**PERSIMMON HOMES THAMES VALLEY
LAND NORTH OF TODDINGTON LANE,
LITTLEHAMPTON**

**DRAINAGE STRATEGY, WEST OF
WETLANDS
(DISCHARGE OF CONDITION 10)**

Project Code:	A/PHDRAIN.10
Prepared by:	SF
Approved by:	AB
Issue Date:	24th January 2019
Status:	1st Issue

From: Laura Gibbons <Laura.Gibbons@arun.gov.uk>
Sent: 16 January 2019 11:05
To: Sean Foley
Cc: Clark, Robert; Michael Eastham; Edgley, Martin; Adrian Barnley; Steven Lecocq; Fatima Evernden; Tracey Headley-Smith; Alex Wray; Adam Winstone
Subject: RE: Planning Consultation on LU/345/18/DOC

Image below: Shows the locations of the permeable sub-base within the Windes model..

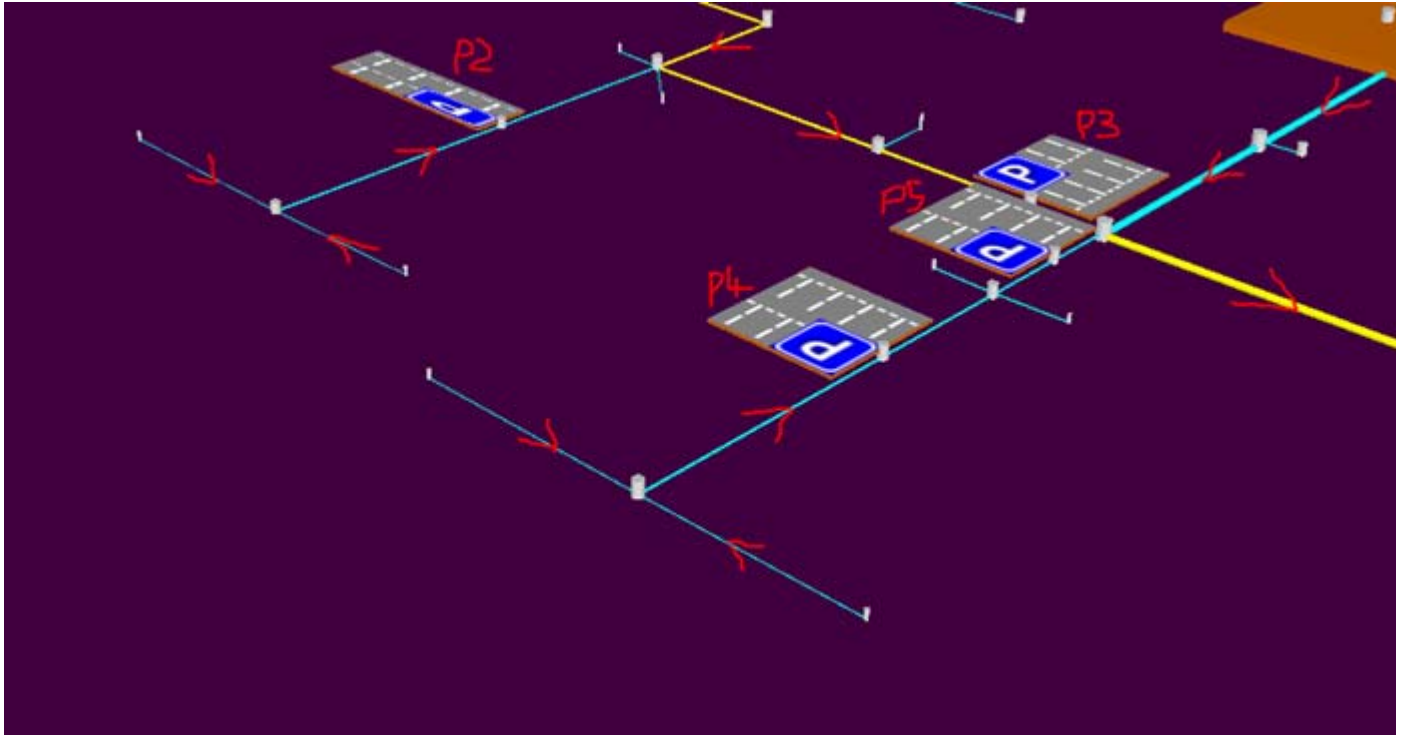
Whilst reading the response below please note we have updated our Windes model so it now includes the permeable sub-base. See image below where we've added new nodes and modelled is as a "porous car park" (function within the programme) where the storage within 30% voids of the granular sub-base is recognised. We have distributed it as evenly as possible across the areas where the granular sub-base is located. The addition improves the results significantly and the total flooding volume for the fully surcharged critical 1in100yr+CC storm is now only 35m3 (spread across 4 different locations) that can safely be contained within the site.

Persimmon Homes (Thames Valley)
Phase 2 Littlehampton
Levels Plan (Sheet 2)

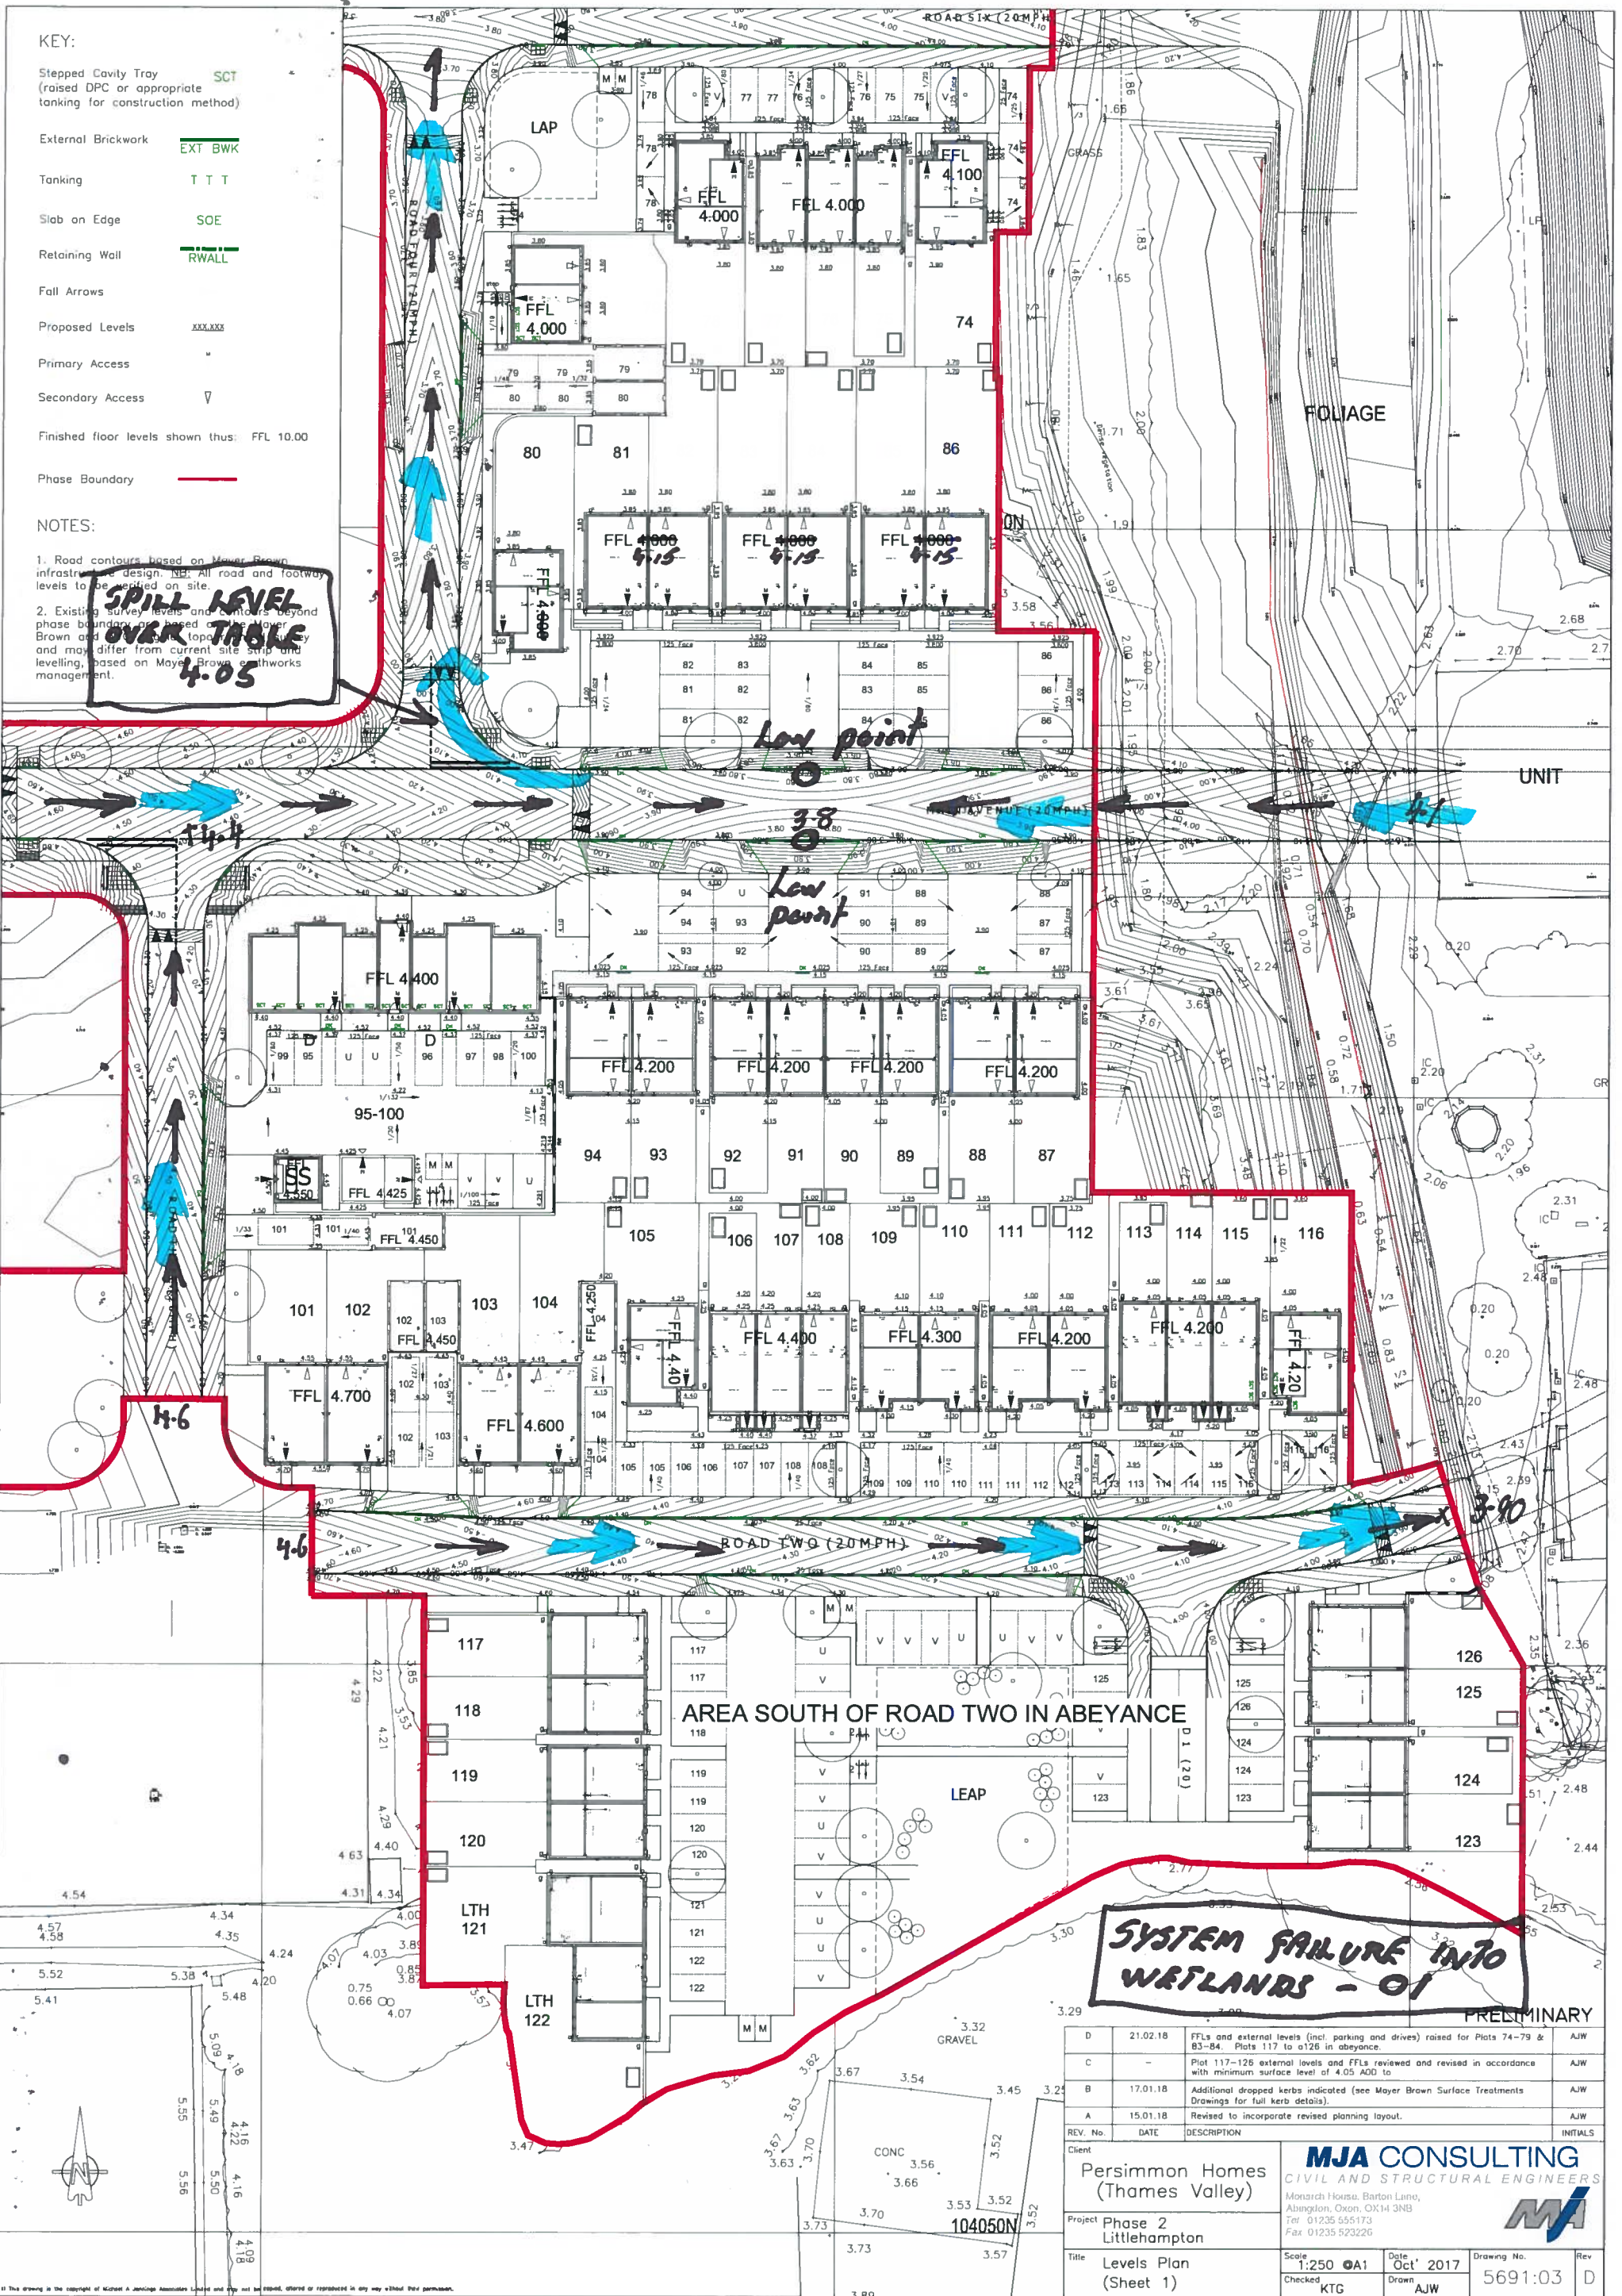
- Attached is the critical storm summary for the 1in100yr+CC event. The critical storm down at the low end of the catchment where the surface flooding occurs is the 240 minute storm. I will review this once point 3 is resolved.
- 3. Can I please see a plan showing FFLs (including garages) and the drainage layout on the same drawings, with references to MicroDrainage PN included. Please also indicate kerb levels in the areas of flooding on this drawing.

- Please find attached the MJA drawings that show the proposed road contours and the building floor levels. We have also identified where the critical 1in100yr flooding occurs on the levels plan. I need to see FFLs, finish, and formation levels of permeable paving, kerb levels, drainage network details including PN on the same plan. I do not believe this to be too onerous an ask. Without this my review is very slow and errors can easily be missed. Drawings need to be of a standard that can easily be interpreted, i.e. construction issue quality.
4. Can you please explain the water levels shown on the road cross section, is this just the MicroDrainage level from a specific location (not taking account of the sub base)?
